SUBDIVISION-LAND DEVELOPMENT WAIVER REQUEST FORM

SUBJECT: **Plan Processing Modification Request**
J. Hubler Landscaping
202 Ridgeview Road North
DCG Project Number **3596-01**

PROPOSED SITE PLAN
 FOR
J HUBLER LANDSCAPING
 202 RIDGEVIEW ROAD NORTH
 MOUNT JOY TOWNSHIP
 LANCASTER COUNTY, PENNSYLVANIA

Re: J. Hubler Landscaping
Land Development Plan Waiver Request
Township Permit No. 25-02-WAIV
LCEC Project No: 25-185

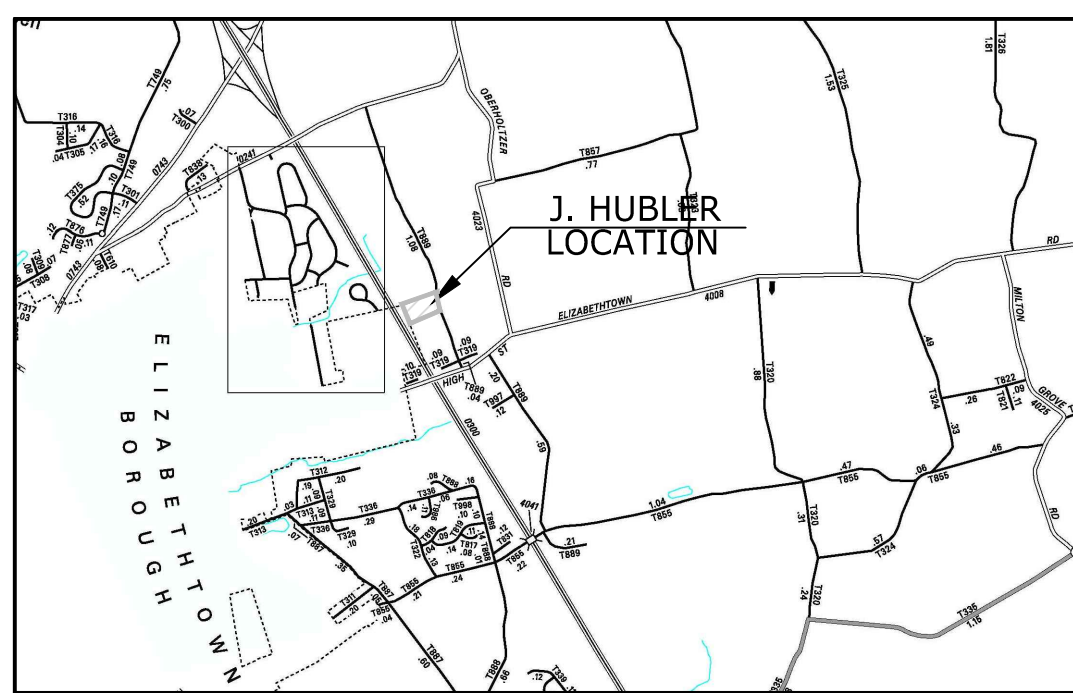
1. Landscape strips and screens shall be installed for landscaping businesses (135-240.C).
2. A landscaping business is permitted as a special exception use within the Agricultural district (135-83.L). A special exception is needed to expand or alter a preexisting use that is permitted by special exception (135-322).

3. An exterior lighting plan shall be submitted (if exterior lighting is proposed) (135-298.D).
4. Stopping sight distances shall be evaluated and a clear sight triangle provided at the driveway (135-299.E(2) & 119-31.D(12)).

5. Riparian corridors shall be established to include 30 feet on each side of the watercourse, measured from the top of each stream bank (135-306.B). The riparian corridors shall encompass, at a minimum, the entire 100 year floodplain and any wetlands (135-306.C). The applicant shall enter into a recordable agreement with the Township providing for the permanent maintenance of the riparian corridor, in a form acceptable to the Township Solicitor (135-306.F). The location of the proposed implement shed is within the riparian corridor of the existing watercourse shown on the proposed site plan.

6. The 1996 subdivision plan recorded in Book J-193, page 12 for Timothy R. and Roxanne M. Grube shows an existing wetland area. Note 7 of the plan states: "If grading is proposed in the wetland area, appropriate permits must be secured from the D.E.P. and any other local agencies as required." (135-306.B(6)). The current plan shows the "Remnants of Previous Soil

Pile” in the proximity of the wetland area. An updated wetland study shall be provided (119-32.B).

7. The site plan should provide the calculations for determining the required off-street parking spaces (135-343.C).

Waiver response: The existing 8.59 acre property has one existing single-family detached dwelling, one existing detached garage/office, and numerous accessory structures (i.e. pole barn, hoop houses) which are to remain. The proposed building will be used to store existing trucks, equipment and supplies that are currently stored outdoors. The proposed development does not intensify the use of the property, and no new employees or increase in traffic are expected to be generated by the construction of the building. Based on these considerations, I have no objections to a waiver of land development with the following conditions:

- a. The Township should consider whether the frontage along Ridgeview Road North (a collector street) should be improved in accordance with 119-52.J or as indicated on the Township Official Map, whichever is greater. Improvements shall include pavement widening, a trail, and additional right-of-way (119-52.J(3)(a)). The required cartway for a collector street outside the urban growth area is 22 feet with 5 foot paved shoulders; the existing cartway varies from approximately 17' to 21' wide. The required right-of-way for a collector street is 60 feet (i.e. 30' from the road centerline along the subject tract); the existing right-of-way width is 25' from the road centerline along the subject tract. If the Township determines that the road improvements required by 119-52.J(3)(a) are not feasible at this time, the applicant could enter into an agreement that would defer road improvements to a time the Township would deem such road improvements as feasible or deposit funds with the Township in the amount of 110% of the cost of improvements (119-52.J(3)(d)).

- b. The Official Map shows a trail along Ridgeview Road North. A pedestrian easement should be provided for the required trail along the entire frontage of Ridgeview Road North (119-62.D).

9. Prior to any earth disturbance, a plan meeting the requirements of the Mount Joy Township Stormwater Management Ordinance shall be submitted to the Township (113-31.A).
